Subject: Byron Station Units 1 and 2 and
Braidwood Station Units 1 and 2
Additional Response to Structural
Engineering Branch Questions
NRC Docket Nos. 50-454, 50-455,
50-456 and 50-457

Question 130.06

QUESTION 130.09

FIGURE Q1.30.6-9
COMPARISON OF B/B AND RG 1.60 SPECTRA
EXCITATION: OBE, HORIZONTAL, NS AND EW
LOCATION: AUXILIARY AND CONTAINMENT BLDG
ELEVATION: 330'-0"; 374'-0"

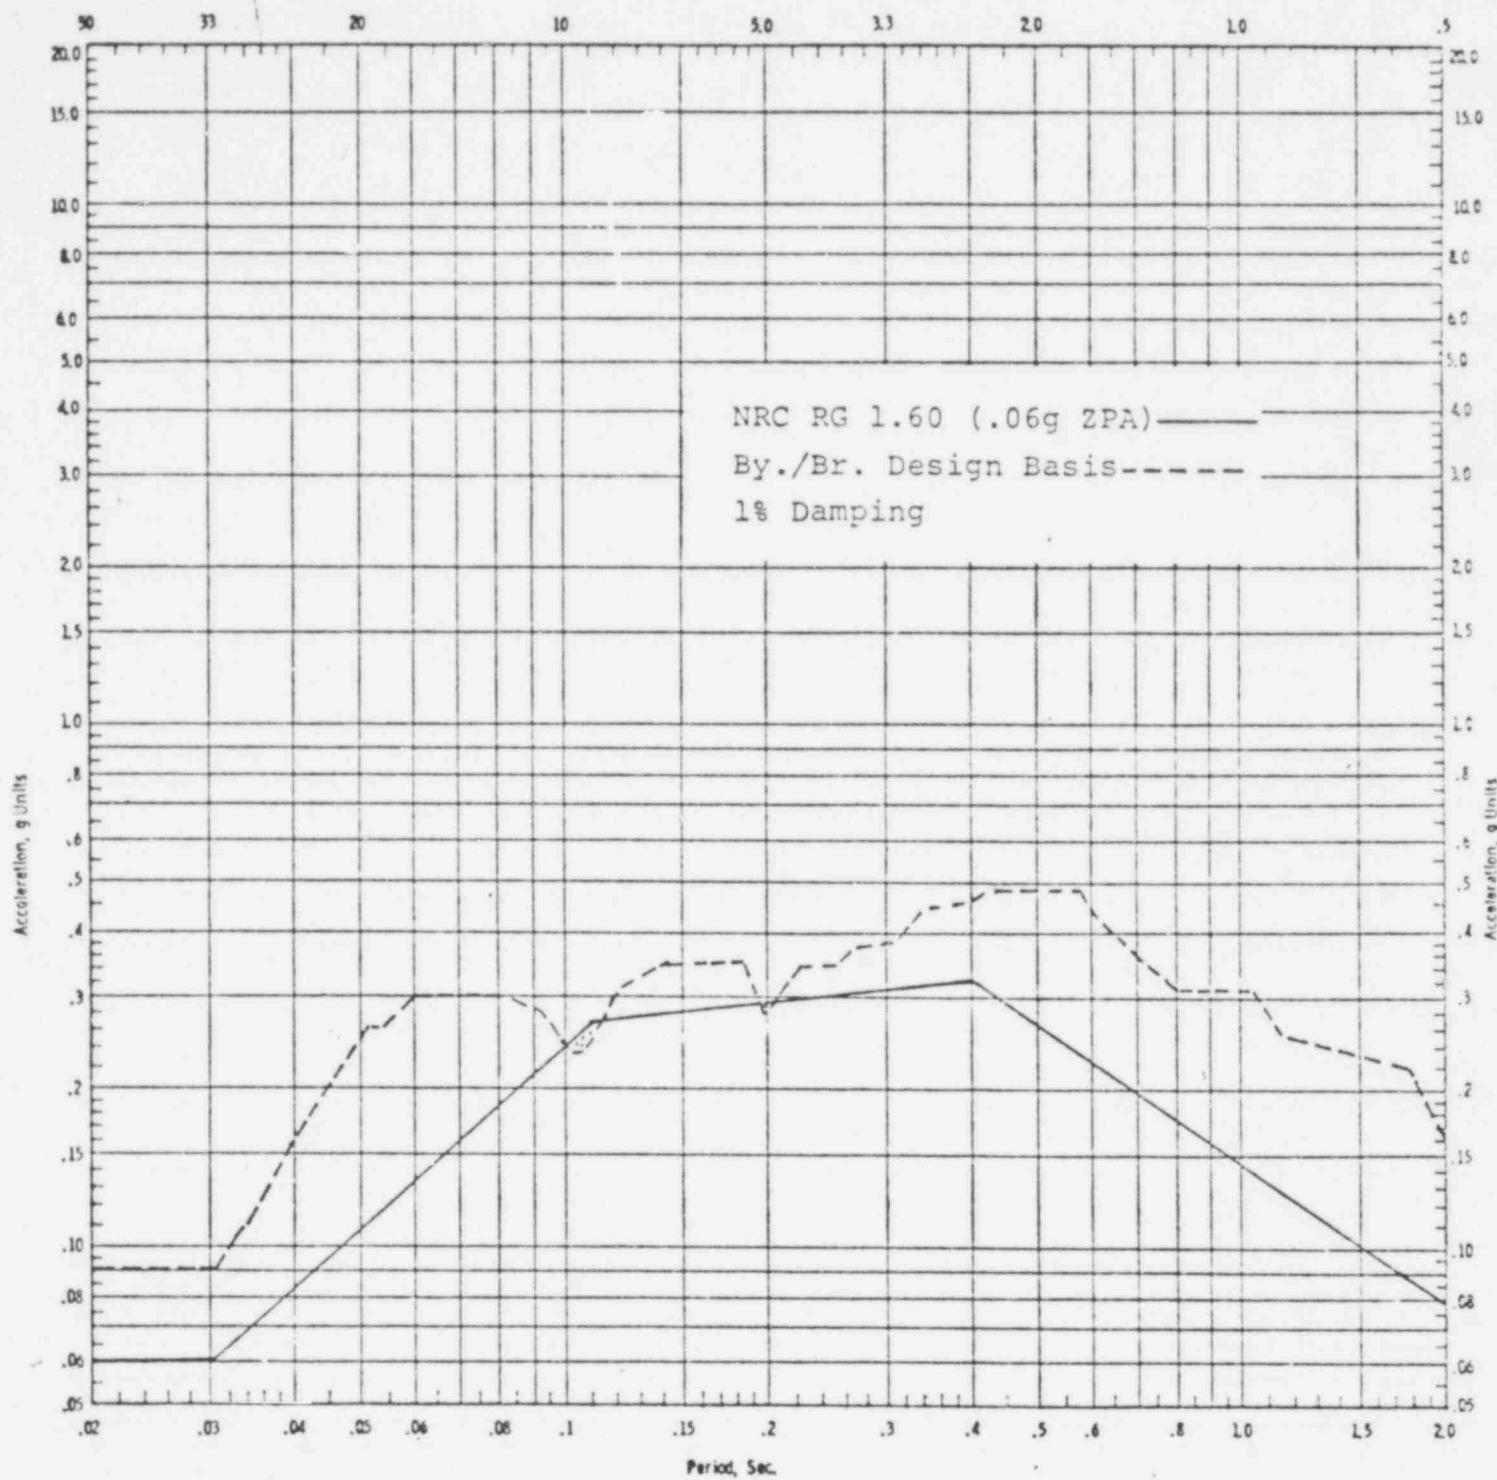
The seismic analysis was performed by the response spectrum method. However, the response spectra at the foundation level generated by the synthetic time history have displayed a significant dip over a large range of frequencies, as compared with the design response spectra in RG 1.60 (Figures 3.7-1 through 3.7-40). The use of such unconservative response spectra is unacceptable to the staff. The deconvolution procedure as described in the FSAR is not appropriate for the Byron/Braidwood sites due to the shallow soil overburden (16 ft to 38 ft) on bedrock. Therefore, it is requested that the analysis shall be based on RG 1.60 free field surface design response spectra applied at the foundation level and the design time history shall generate response spectra envelope the RG 1.60 design response spectra at the foundation level.

input are lower than those used for design. Figures 130.06-9 through 130.06-36 provide a comparison of the present design floor response spectra with those obtained using 0.06 g OBE and 0.12 g SSE RG 1.60 spectra. OBE spectra are for 1% oscillator damping, whereas SSE spectra are presented for 2% oscillator damping. The comparison is provided for both horizontal and vertical responses in the containment and the auxiliary building complex. Table 130.06-3 lists the location and elevations for the spectra comparison. The comparison shows that the present design spectra are higher and, except for a few isolated instances, they envelope those obtained using the RG 1.60 spectra.

RIVER SCREEN HOUSE HORIZONTAL EW
OBE SPECTRA AT EL. 744'-0"

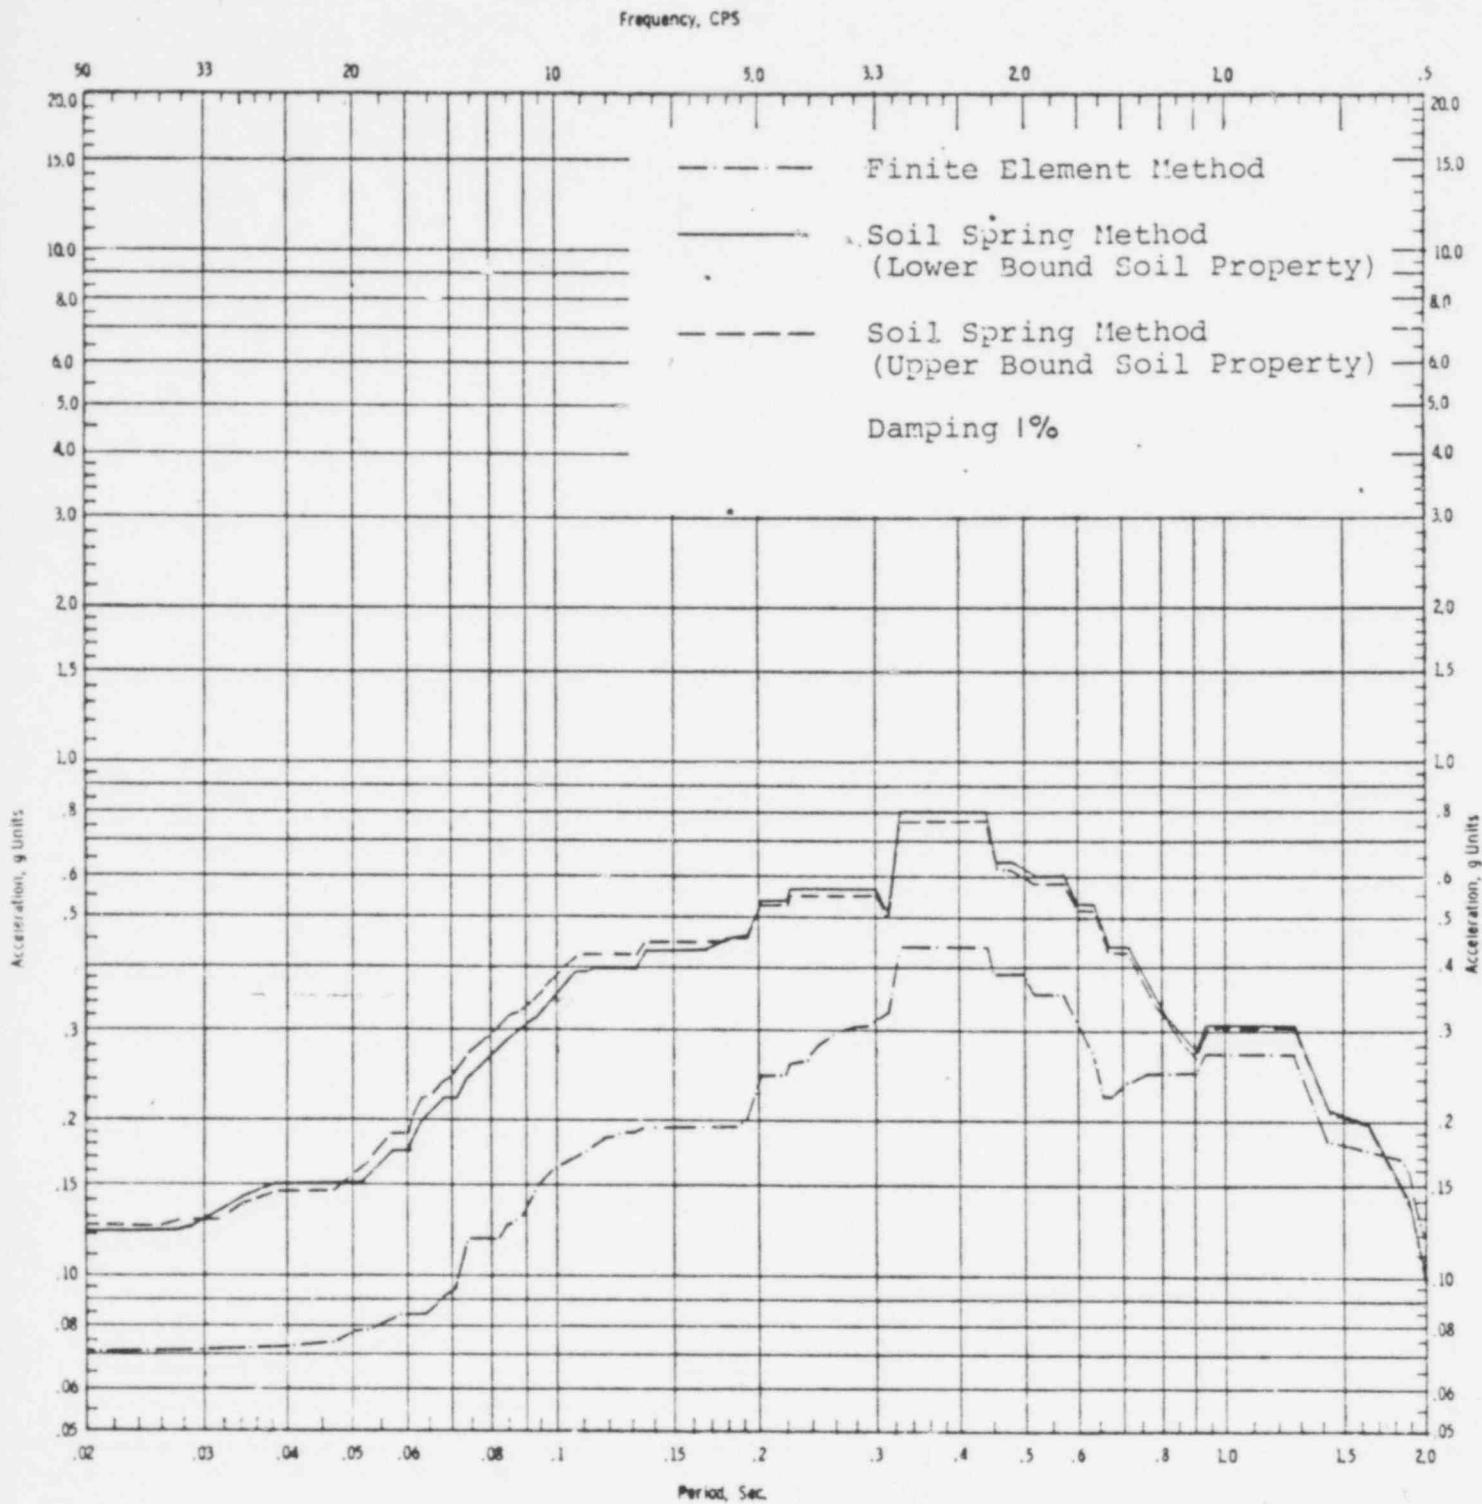
Floor response spectra should be provided at least at the basemat, an intermediate elevation, and an upper elevation. For the lumped parameter representation, the variation of soil properties should be considered.

The horizontal floor response spectra at the basemat (el. 664'), an intermediate elevation (el. 702'), and the roof (el. 744') are presented in Figures 130.09-1 through 130.09-6 for the OBE and in Figures 130.09-7 through 130.09-12 for the SSE. The response spectra are generated for 1% damping for OBE and 2% damping for SSE. The dot-dash line represents the design basis, using the finite element method (FEM). The solid line and dash line are those obtained by the half-space solution using the lower and upper bounds, respectively, of the soil properties. Table 130.09-3 lists the comparison of the selected shear wall forces obtained using the soil spring soil-structure interaction (SSI) response spectra and the finite element SSI response spectra. Figures 130.09-13 and 130.09-14 provide the locations of the shear walls. The shear walls were evaluated to these higher forces and the stresses were found to be within the allowable.
